# A. General

# Other Lands Owned by Licensee

## **Final Rehabilitation** A. General

Site P	lan Amendments					
No.	Date		Descript	ion		Ву
-	lan Revisions (Pr		Descript			
		-				
1.	September 2020	Adjust pond adjacent to dw Included MNRF wetlands for	-

Cross Section A-A1

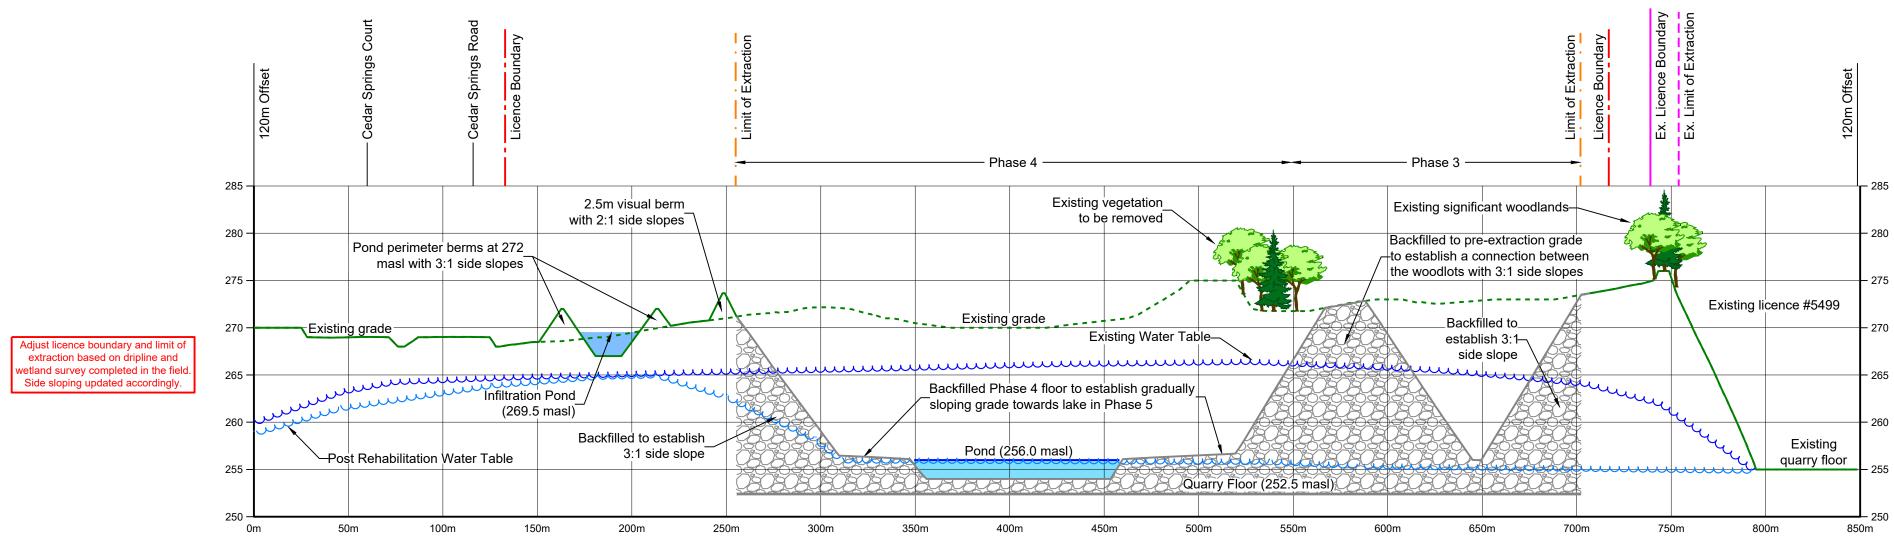
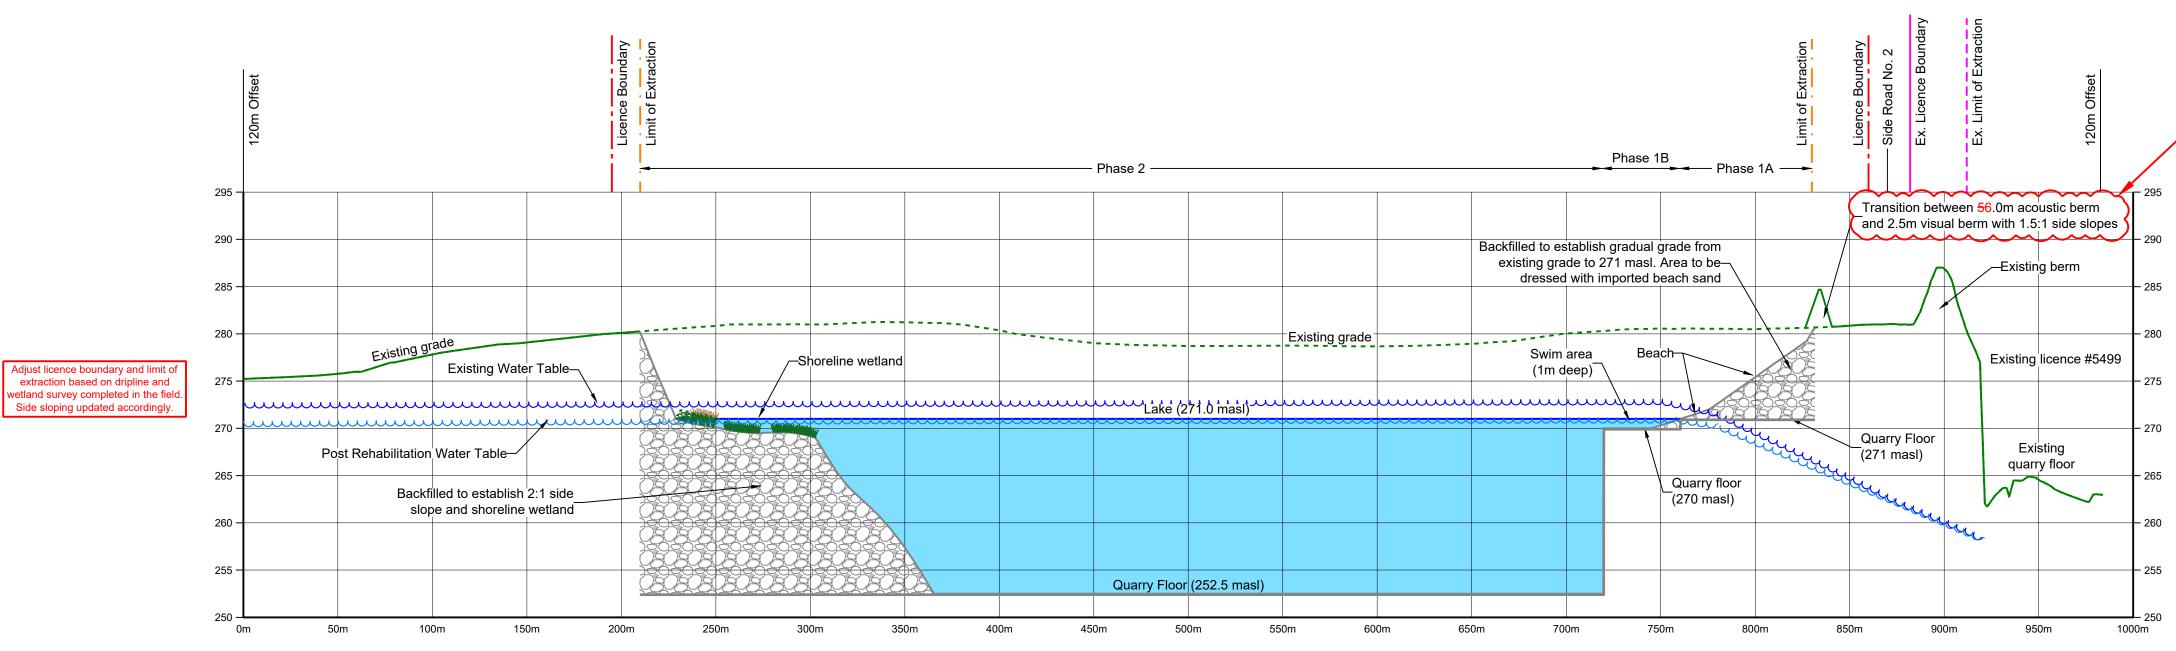
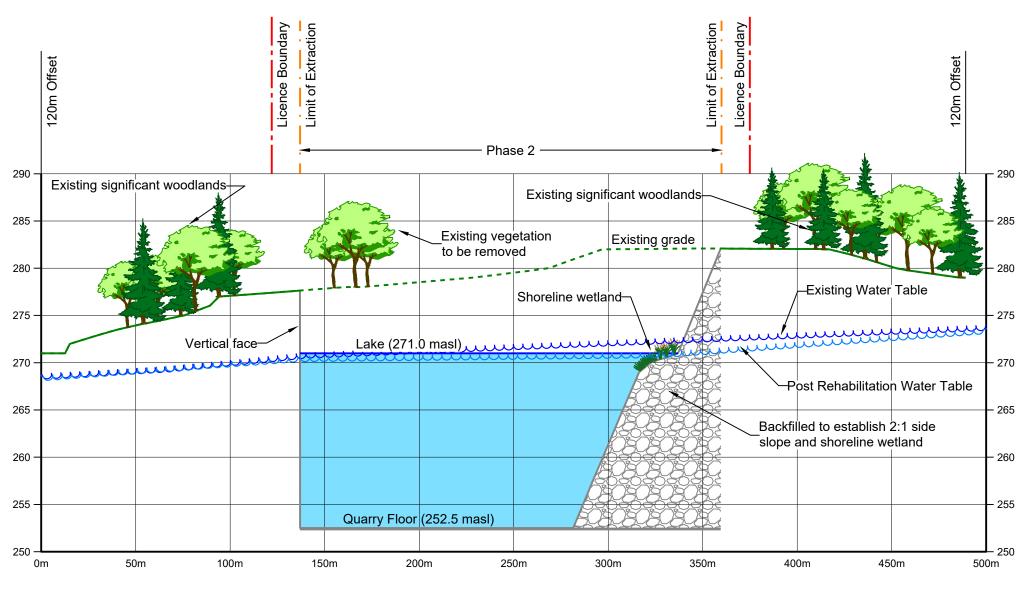
Adjust licence boundary and limit of extraction based on dripline and wetland survey completed in the field. Extraction face and side sloping updated accordingly.

No.	Date		Description			Ву
Site Pl	an Revisions (Pre-Lice	encing)				
1.	April 2021	Added	additional cross section l	abels for clarity.		CAF
2.	January 2022	Up	dated to address agency	comments.		CAF
No.	Date		Description			Ву
	113 COLLIER STRE	T MH ET, BARRIE, ON, L4M		JRBA & LA ARCI	nd NDS HITE(	ING ESIGN CAPE CTURE
	DF	<b>R</b>	FT		J	
\pplic	ant		NELS GGRE D. 2433 No. 2 P.O.Box 10 phone: (90	<b>ON</b> <b>EGA</b> Sideroad O70 Burlington C 5) 335-5250	• <b>5</b> • <b>5</b> ••••••••••••••••••••••••••••••	A Contraction of the second se
Applic	ant		NELS GGRE D. 2433 No. 2 P.O.Box 10 phone: (90			
Applic	ant	ton Q	NELS GGRE D. 2433 No. 2 P.O.Box 10 phone: (90	Exte		
Applic	t Burling	ton Q	NELS GGRE D. 2433 No. 2 P.O.Box 10 phone: (90 Uarry	Exte		
Applic Projec	t Burling Licence Reference No 626477	ton Q	NELS GGRE D. 2433 No. 2 P.O.Box 10 phone: (90 Uarry	Exte	nsi	on
Applic Projec MNRF	t Burling Licence Reference No 626477	ton Q	NELS GGRE D. 2433 No. 2 P.O.Box 10 phone: (90 Uarry Pre-approval	<b>Exte</b> review: Ja		on
